[Docket No. 2001-SW-53-AD]

Airworthiness Directives; Bell Helicopter Textron Canada Model 407 Helicopters

ACTION: Notice of proposed rulemaking (NPRM).

Figure 1. Preflight Check of the Tailboom

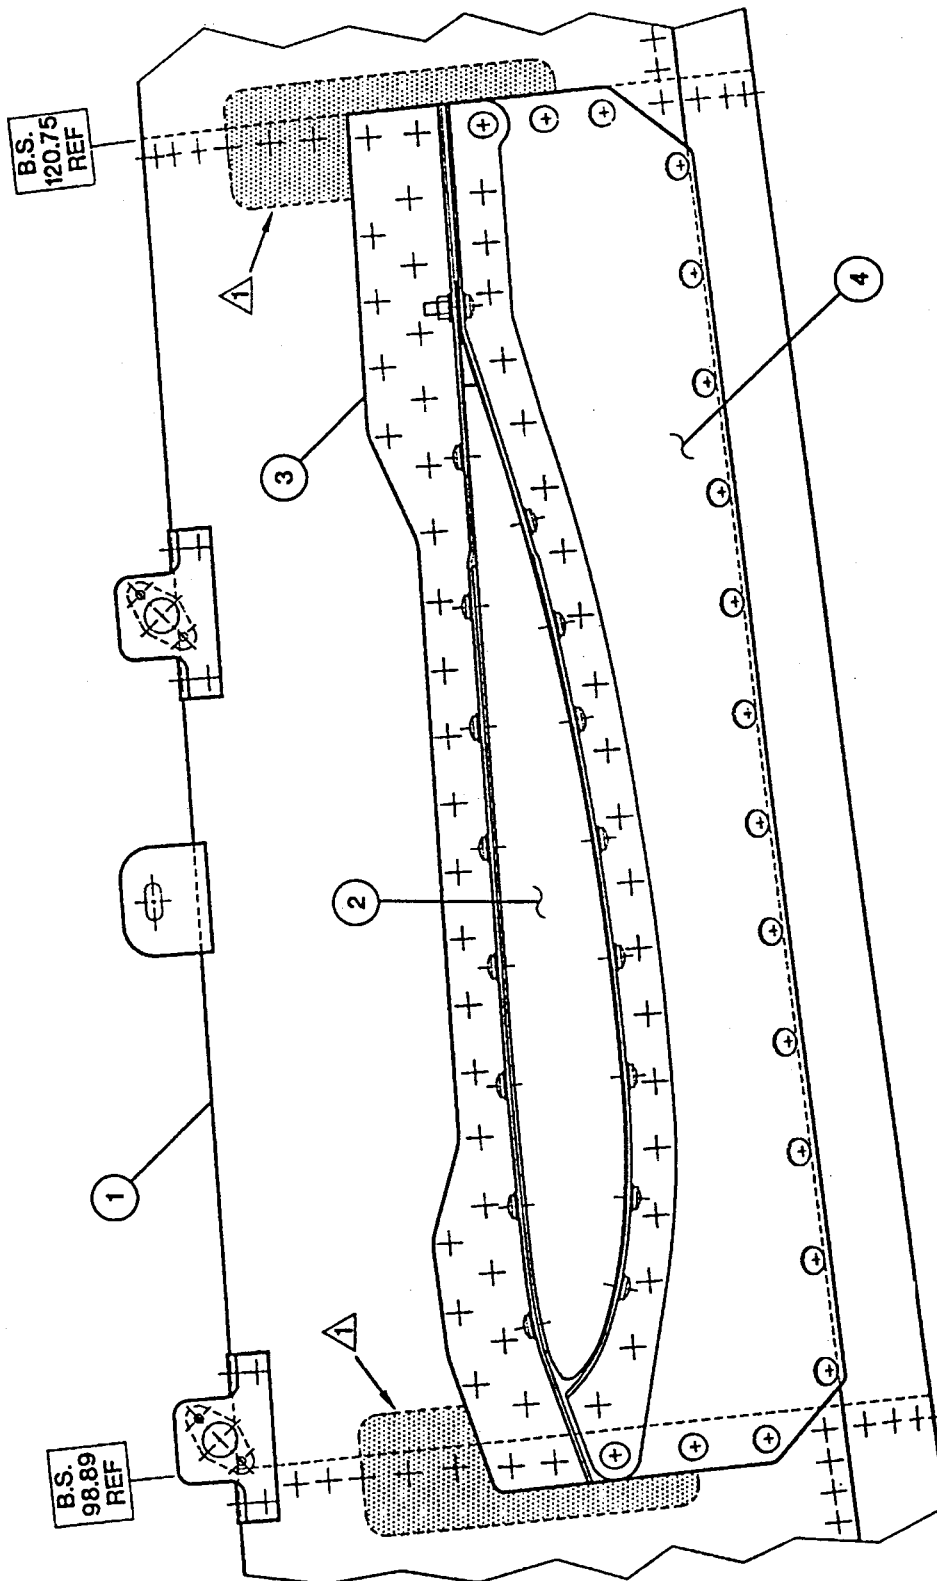
(a) Before further flight and thereafter before the first flight of each day, check the tailboom for a crack in accordance with Figure 1 of this AD. If a crack is found,

1. Examine these areas for cracks on left side of tailboom only.
2. Horizontal stabilizer not shown for clarity.
